MARTIN COUNTY, FLORIDA DEVELOPMENT REVIEW

STAFF REPORT

SW 96th STREET CONVENIENCE STORE MINOR FINAL SITE PLAN

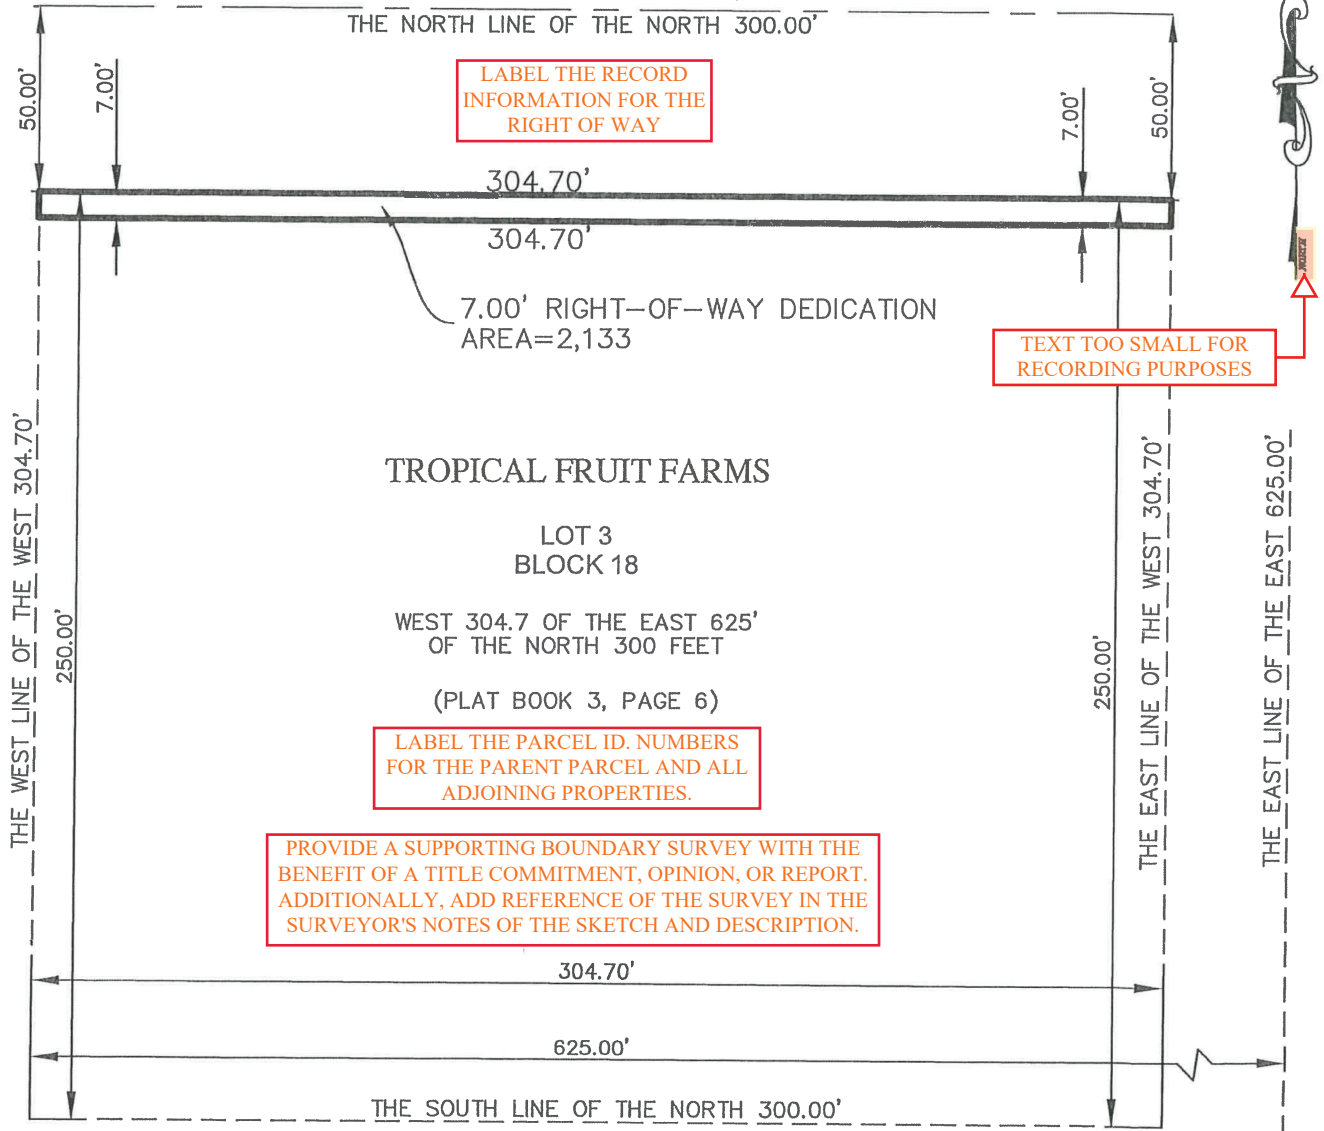
REVISE STATEMENT AS THERE ARE NO BEARINGS AND NO LINE LABELED "BEARING BASE".

ADD THE MARTIN COUNTY'S ADA STATEMENT

PROVIDE A SUPPORTING BOUNDARY SURVEY WITH THE BENEFIT OF A TITLE COMMITMENT, OPINION, OR REPORT. ADDITIONALLY, ADD REFERENCE OF THE SURVEY IN THE SURVEYOR'S NOTES OF THE SKETCH AND DESCRIPTION.

DRAWING DOES NOT PLOT TO SCALE. REVISE ACCORDINGLY
